**STATE SIGNIFICANT DEVELOPMENT
ASSESSMENT REPORT:
Site 68 Sydney Olympic Park
(SSD 6603)**

Secretary's Environmental Assessment Report
Section 89H of the *Environmental Planning and
Assessment Act 1979*

June 2015

Figure 9: Extract of the Height Control Map under the MD SEPP

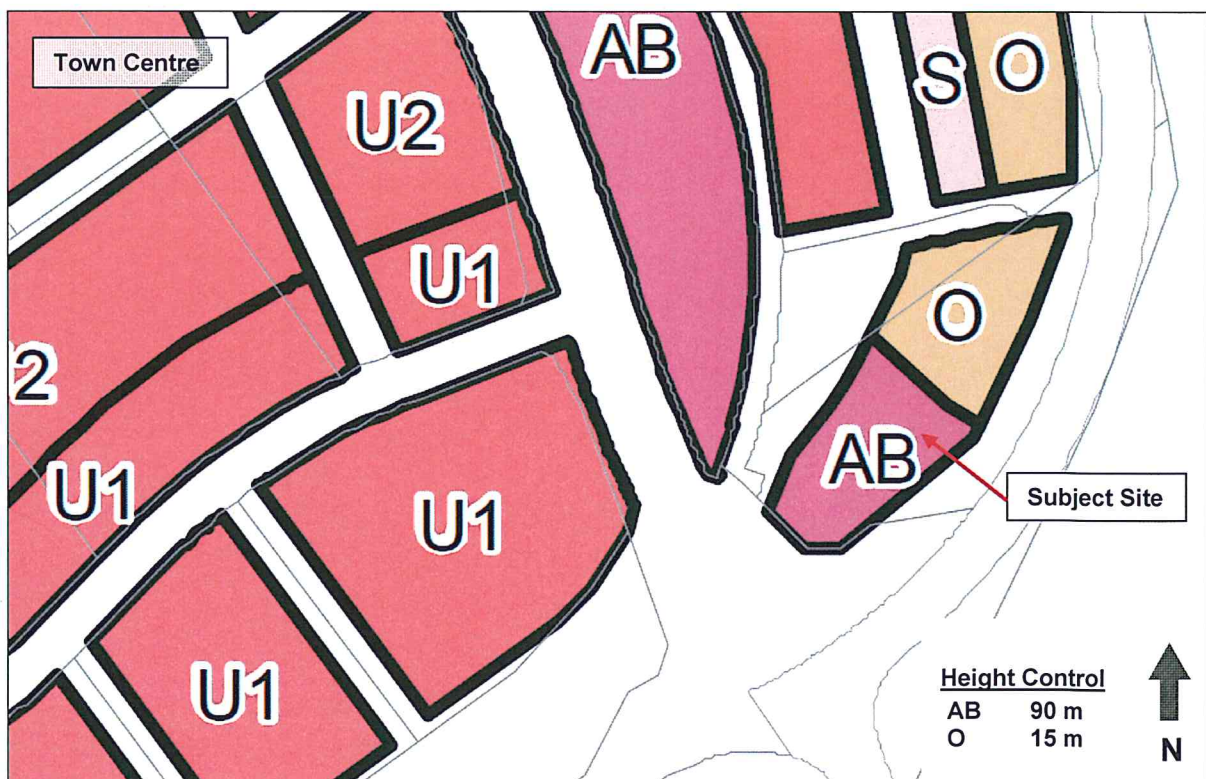
The MD SEPP prescribes two height limits for the subject site. The maximum height in the northern part of the site is 15 m; stepping up to 90 m in the southern part of the site (refer to an extract of the MD height control map at **Figure 9**).

The proposed residential tower in the southern part of the site has a maximum building height of 110.7 m and therefore exceeds the maximum 90 m height control by 20.7 m, representing a variation of 23 per cent above the height control. The extent of the variation is illustrated in **Figure 10**. The rooftop plant is excluded from the building height in accordance with the definition of building height under the MD SEPP.

Figure 10: North elevation illustrating the variation to the height control

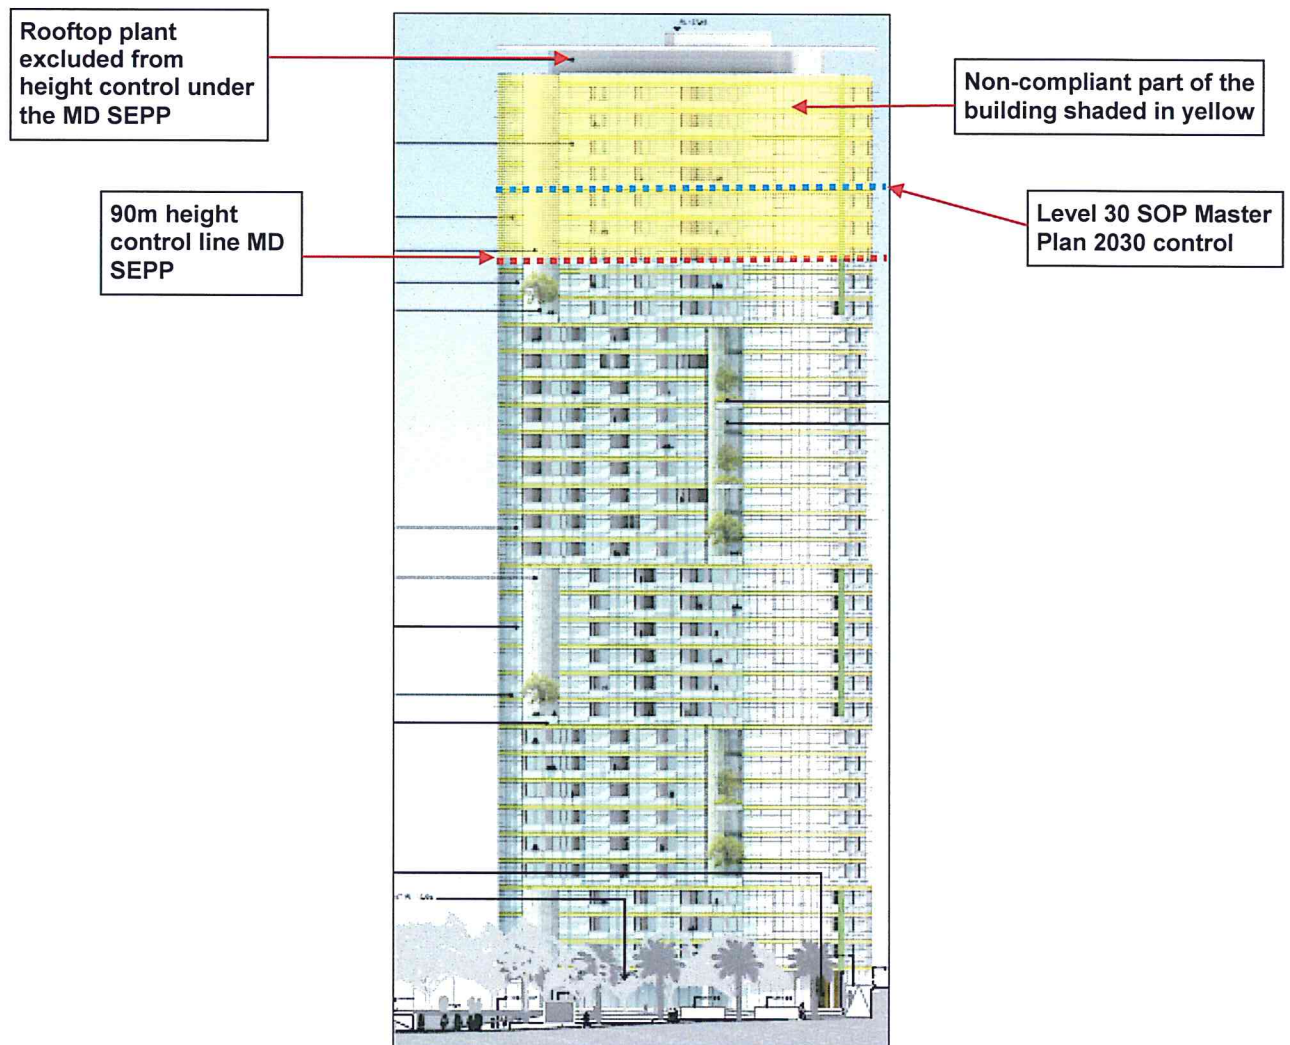
The applicant considers the variation above the building height control to be reasonable on the basis that the proposal has been subject to on-going consultation with SOPA and the SOPA Design Review Panel, who have provided support for the proposed re-distribution of floor space from the four-storey podium and thirty-storey tower building envisaged under the SOP Master Plan 2030, to a slender tower with landscaped ground plane and separate child care centre. The applicant also contends the proposal is the direct result of a design competition, in which recommendations were made by the SOPA Design Review Panel to increase the size of the vertical slots and redistribute the lost residential floor space to the top of the building, thus increasing the overall height of the building. The Department notes that the additional height and FSR and the separated built form arrangement (between the residential tower and future childcare centre) is generally supported by SOPA.

The applicant's justification for the variation above the building height control is also based on the need for an iconic building at a gateway location to SOP for those approaching the precinct from the south on Australia Avenue. The applicant also considers the proposed development is consistent with the desired future character of the precinct and would not result in any unreasonable amenity impacts to the surrounding area.

The Department considers the proposed building would successfully identify the southern gateway to the town centre at the end of a row of towers along Australia Avenue, which would reinforce the SOP skyline (refer to **Figure 11**). The non-compliant part of the building above the height control would result in some additional overshadowing to the south and east of the site, which equates to approximately 17.5 per cent of the total shadow cast by the building. However, the Department considers that the building's curved triangular design and the short duration of shadow would result in acceptable shadow impacts on Bicentennial Park (refer to discussion in **Section 4.2.6**). The Department is therefore satisfied the proposed development is consistent with the objectives of the height control in SOP Master Plan 2030.

Figure 12: Solar Access

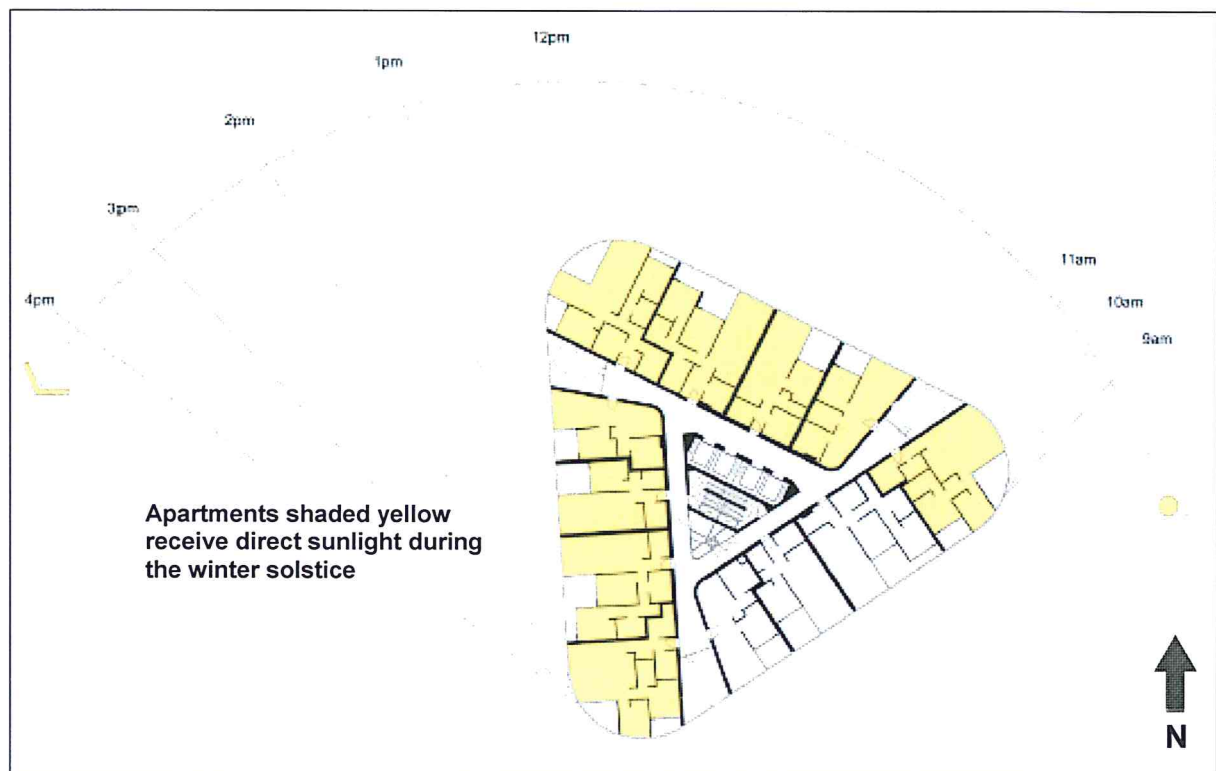
In its submission on the original EIS, SOPA commented that the applicant's analysis should be reduced to between 9 am and 3 pm and justification provided for any departure from the solar access requirements in the SOP Master Plan 2030. The Department notes that the controls in SOP Master Plan require a minimum of three hours solar access to at least 75 per cent at the winter solstice, and the 70 per cent target nominated by SOPA is the requirement under the RFDC.

Despite the shortfall of 10 per cent, the Department is satisfied that the design maximises the number of apartments receiving solar access as illustrated in **Figure 12**. In addition, an acceptable number of apartments are still able to achieve satisfactory levels of amenity, with the building design and layout maximising high quality views and minimising the number of apartments exposed to rail and major event noise sources. Apartment layouts have also been designed to place non-habitable rooms towards the inside of apartments (i.e. kitchens, bathrooms etc.) so as to maximise natural light, ventilation and views for habitable rooms.

Further, the presence of the open vertical slots in the building's façade helps achieve higher levels of amenity by conveying natural light and ventilation on every floor, as well as additional view aspects from the internal building core through the vertical slots. The Department's assessment concludes there would be adequate solar access and amenity for future occupants of the development.

Figure 14: Shadow Impacts – 9 am winter solstice

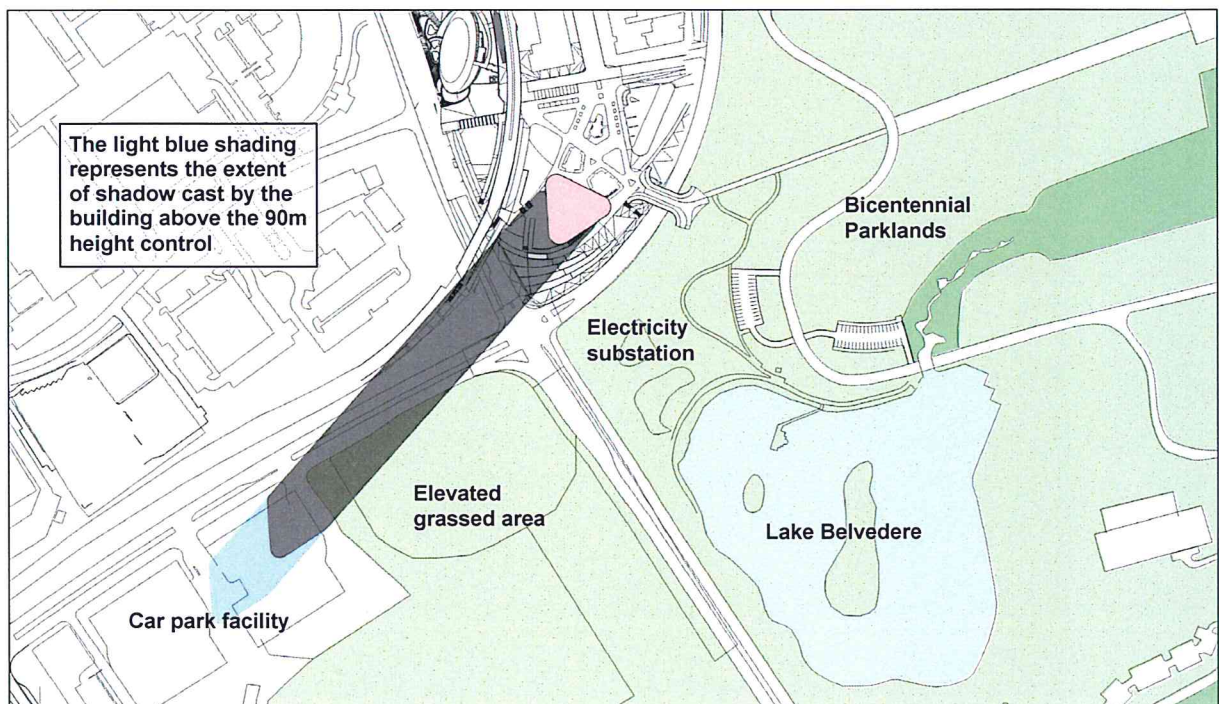
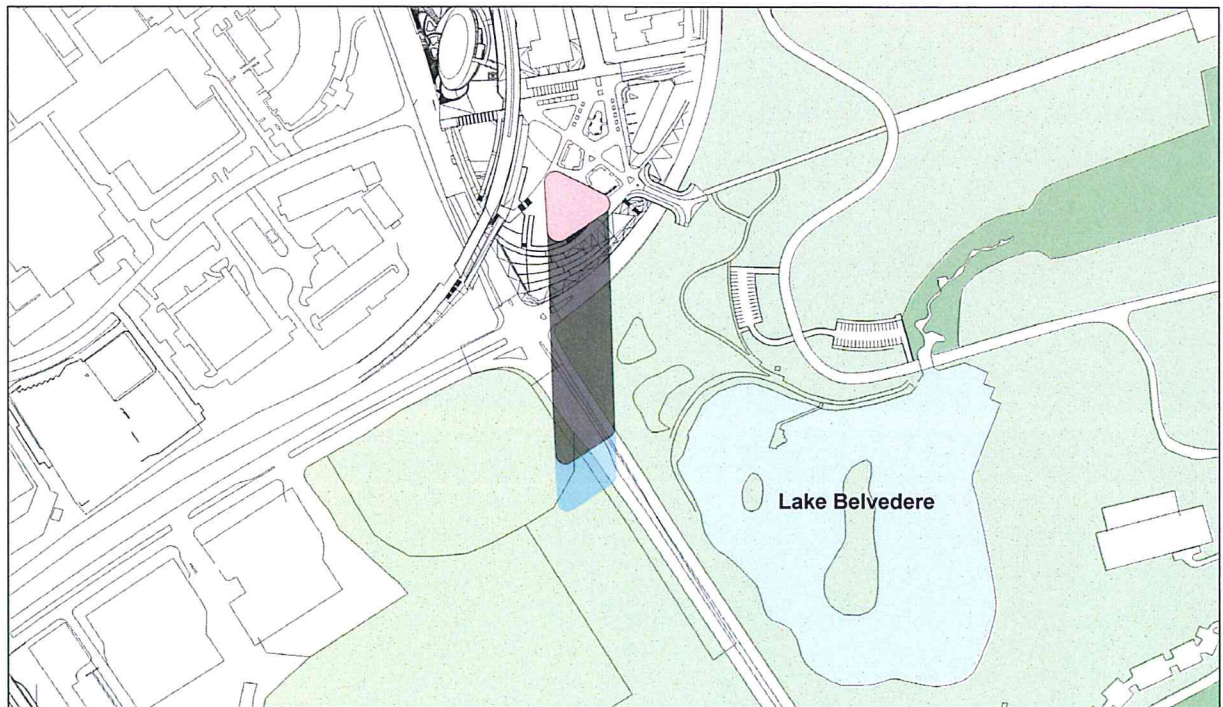
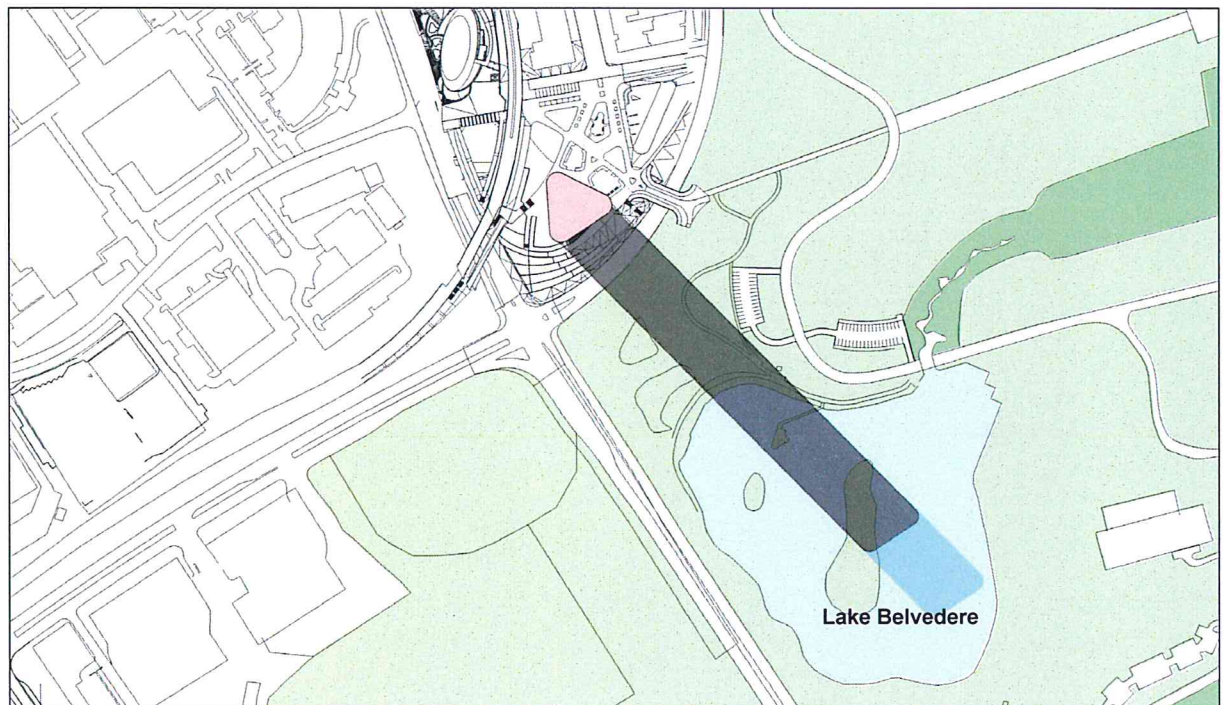
In its submission on the original EIS and subsequent RtS, SOPA raised concern regarding the potential shadow impacts from the proposed residential tower on island nesting sites for bird species such as darters, cormorants and spoonbills known to be present within Lake Belvedere. In response, the applicant has provided shadow diagrams which illustrate that the mid-winter shadow cast by the tower building has an average duration of only one to 1.5 hours maximum at only given point, resulting in minimal impact on existing habitat. In a subsequent letter to the Department dated 16 June 2015, SOPA concurred with these findings and raises no further issues regarding impacts on Lake Belvedere. The Department is satisfied the overshadowing impacts to Lake Belvedere have been lessened by the proposed slender building form and resulting short duration of shadow (refer to Section 4.2.6 Overshadowing).

To illustrate the potential overshadowing impact associated with the proposal, the applicant submitted hourly shadow diagrams between 9 am and 3 pm, representing the worst case scenario at the winter solstice (refer to **Figures 14 to 16**). Between 9 am and 12 noon the shadow cast by the proposed building affects the existing car park station and an elevated grassed area on the south-western side of Australia Avenue. Between midday and 3 pm the shadow cast by the proposed building affects the parklands on the north-eastern side of Australia Avenue, which includes an electricity substation at the corner of Australia Avenue and Bennelong Parkway, and Lake Belvedere further south. The applicant's BOS concluded that the overshadowing impacts to potential off-site GGBF habitat are minor given the short duration of the shadow (the shadow falling on Lake Belvedere and adjacent parklands has an average duration of only one to 1.5 hours).

The Department notes the overshadowing impacts to Bicentennial Parklands have been minimised by the unique tower building form. The shadow diagrams illustrate the islands in Lake Belvedere are affected for approximately one hour between 2 pm and 3 pm at the winter solstice. The Department is therefore satisfied that the proposed development would not result in any unreasonable overshadowing impacts to Lake Belvedere.
